UNITED STATES PATENT AND TRADEMARK OFFICE

APPLICATION NO.	FILING DATE	FIRST NAMED INVENTOR	ATTORNEY DOCKET NO.	CONFIRMATION NO.
10/826,400	04/19/2004	Anthony Sudano	1062742	9923
59152 7590 07/02/2007 OSLER, HOSKIN & HARCOURT, LLP (AVESTOR) 1000 DE LA GAUCHETIERE STREET WEST SUITE 2100 MONTREAL, QC H3B-4W5 CANADA			EXAMINER ALEJANDRO, RAYMOND	
			ART UNIT 1745	PAPER NUMBER
			MAIL DATE 07/02/2007	DELIVERY MODE PAPER

Office Action Summary	Application No. 10/826,400	Applicant(s) SUDANO ET AL.	
	Examiner Raymond Alejandro	Art Unit 1745

DETAILED ACTION

FIG. 6

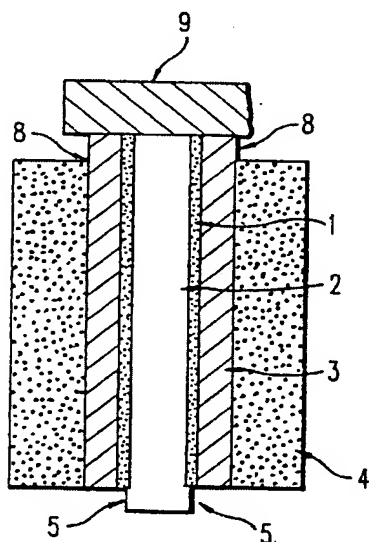
Figure 6 of Gauthier et al is the basis for the anticipation analysis.

Gauthier et al teach electrical contacts 9, 10 (COL 9, lines 44-50) which consists of metal added at the lateral ends of the assembly once the assembly is stacked in its final form (COL 6, lines 40-45).

Figure 6 below shows insulating plastic support film 2 which is a polymeric synthetic resin (COL 3, lines 55-60/ COL 4, lines 41-60/ COL 9, lines 29-32/EXAMPLE 1); metallic films 1 and metallic deposit 3 on both sides of the support film 2 (COL 3, lines 55-60/ COL 4, lines 10-27/COL 9, lines 21-35/Example 1); and electrode layers 4 (COL 9, lines 33-36/EXAMPLE 1). Reference numeral 8 is the conductive lateral margin of the current collector; and reference numeral 5 is the lateral margin of the plastic support film. Gauthier et al disclose that collectors can be made from at least Sn (COL 2, lines 12-15). *In this case, the electrical contact 9 is defining a space itself in which the ends of the current collector (i.e. the metal-coated support film constituted by reference numerals 1-2-3) are received, and a ductile electrically conductive*

material (namely, Sn) is part of the electrical contact itself and is adapted to form an electrical connection therebetween.

Examiner's note: as to the limitation "adapted to", it is contended that this limitation does not distinguish over prior art because the recitation that an element/feature/member is "adapted to" perform a function is not a positive limitation but only requires the ability to so perform. See MPEP 2111.04.

In this case, the electrical contact 9 is defining a space itself in which the ends of the current collector (i.e. the metal-coated support film constituted by reference numerals 1-2-3) are received and crimped, and a ductile electrically conductive material (namely, Sn) is part of the electrical contact itself and is adapted to form an electrical connection therebetween. See FIGURE 6. It is noted that the term "crimp" means "to form into a desired form" or "to pinch or press together" as per Merriam-Webster's Collegiate Dictionary (10th Edition). Thus,

portions of the electrical contact 9 crimps onto the ends of the current collector constituted by the metal-coated support film constituted by reference numerals 1-2-3.

Fig. 2

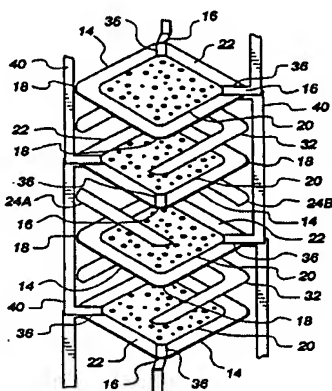
Nachles et al disclose an electrically conductive material 40 (*the electrical contact*) which is in electrical contact with the interconnect strips 36 (*the current collecting elements*) on the underside of the top electrolyte plate 14 (COL 7, lines 29-48). A plurality of solid electrolyte plates arranged into a stack, each electrolyte plate having electrode material adherent thereto is disclosed (ABSTRACT). A metal such as Ag, Ag-alloy or Pt is used as the electrically conductive material (COL 5, lines 33-45)

In this case, the electrically conductive material 40 itself defines a space in which the ends of the interconnect strips 36 are received and crimped; and the electrically conductive material itself represents the ductile material forming the electrical bridge. Note that a metal such as Ag, Ag-alloy or Pt is used as the electrically conductive material (COL 5, lines 33-45). Notice also that the degree of ductility is unknown, thus, the foregoing metallic materials are capable of being fashioned or changed into a new form.

In this case, the electrically conductive material 40 itself defines a space in which the ends of the interconnect strips 36 are received and crimped; and the electrically conductive material itself represents the ductile material forming the electrical bridge. See FIGURE 2. It is noted that the term "crimp" means "to form into a desired form" or "to pinch or press together" as per Merriam-Webster's Collegiate Dictionary (10th Edition). Thus, portions of the electrical contact 40 crimps onto the ends of the interconnect strips 36.
